CITY PLAN COMMISSION STAFF REPORT

Project Name
Maple Park Plaza

5.1 CD-CPC-2023-00059
Area Plan Amendment
5.2 CD-CPC-2023-00056
Rezoning to UR/MPD

SITE PLAN
 PROJECT: _____ DATE: 5-16-23
 SHEET NUMBER: **C102**

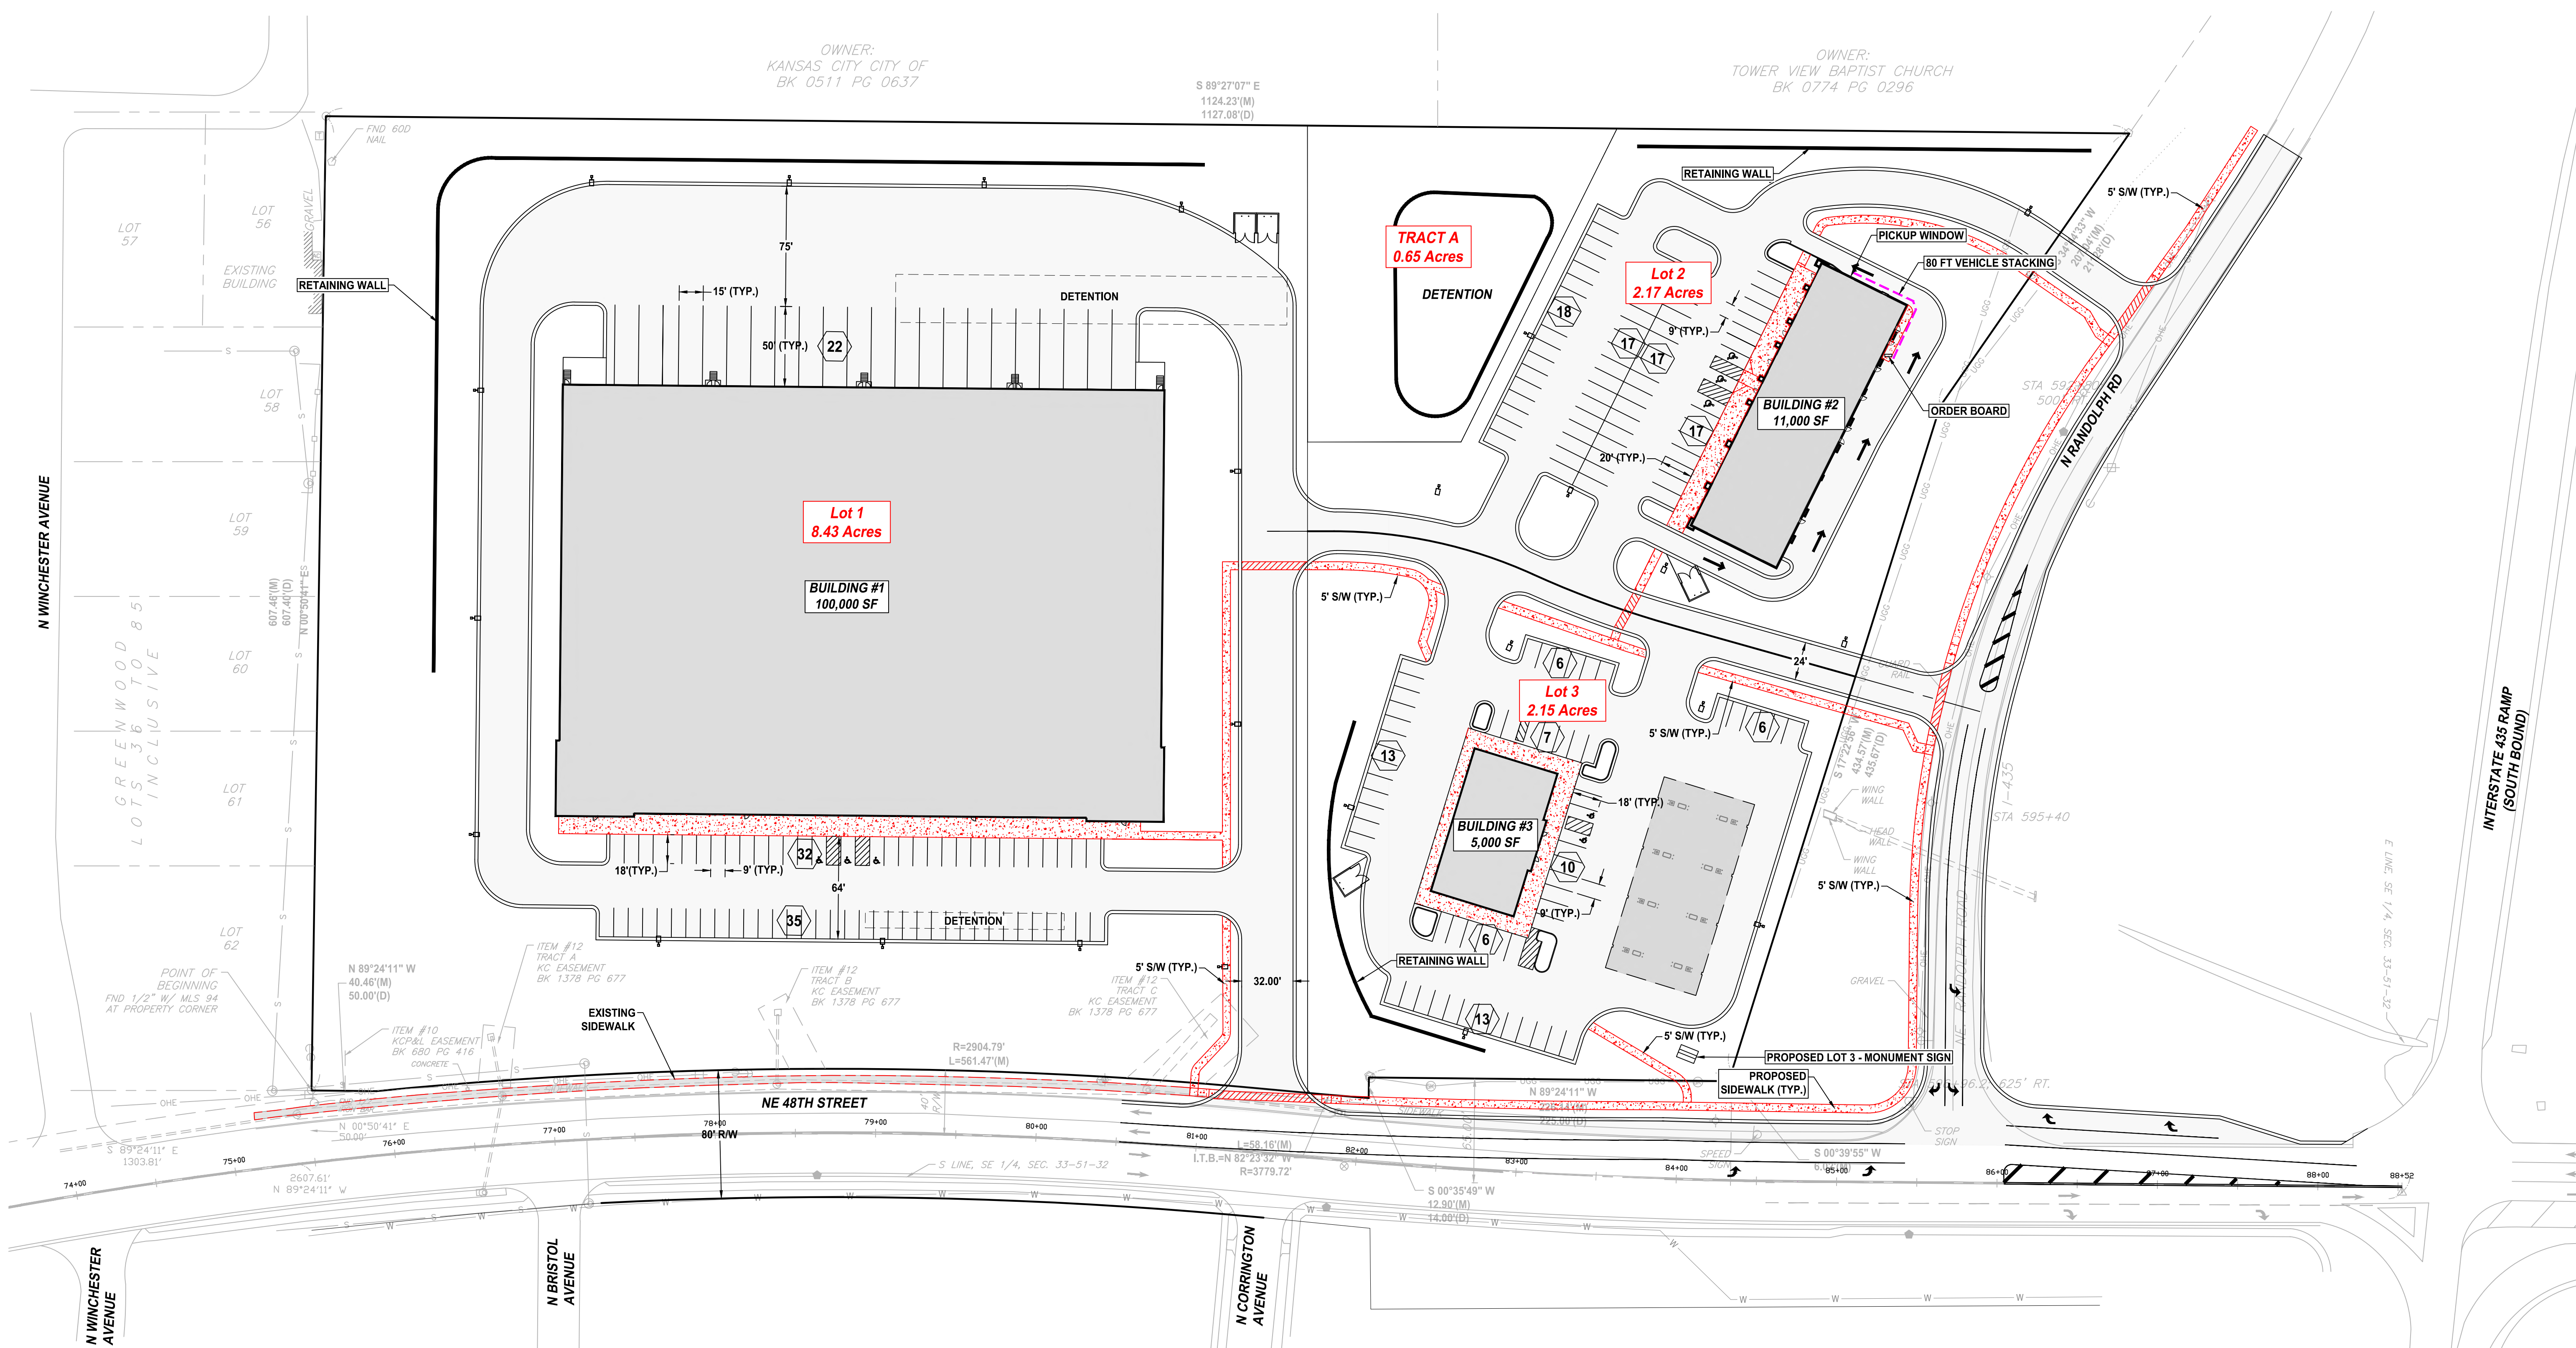
The plan does not specify allowed uses on specific lots; therefore, a different developer may build warehousing, wholesaling, storage, or freight movement on any or all of the three lots, rather than what is proposed. Approving this MPD may have long-term negative implications for nearby residents.

LANDSCAPE BERM
NOT TO SCALE

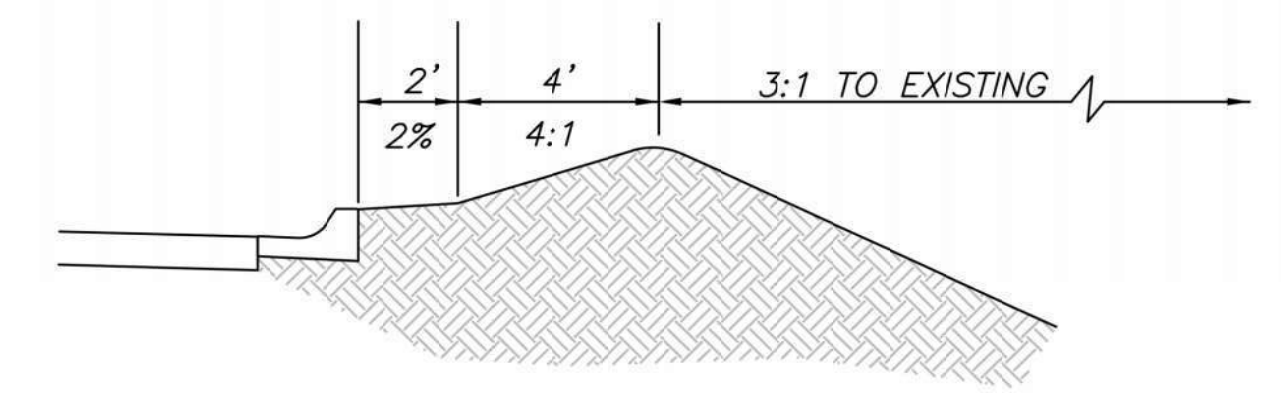
Drive-through and vehicular use areas will be screened with landscaping. Staff requested a berm be added in addition to landscaping for screening of the light industrial building on Lot 1 along NE 48th Street. Proposed plant species include Eastern Redbud, Swamp White Oak, Spruce, Cedar, Sugar Maple, St. Johnswort, and Chokeberry.

Landscaping and screening is in compliance with 88-425. At staff's request, the applicant added a berm to better screen the proposed industrial building from NE 48th Street. The west side of the industrial building is expected to be primarily screened by the retaining wall due to the 20 foot grade change.
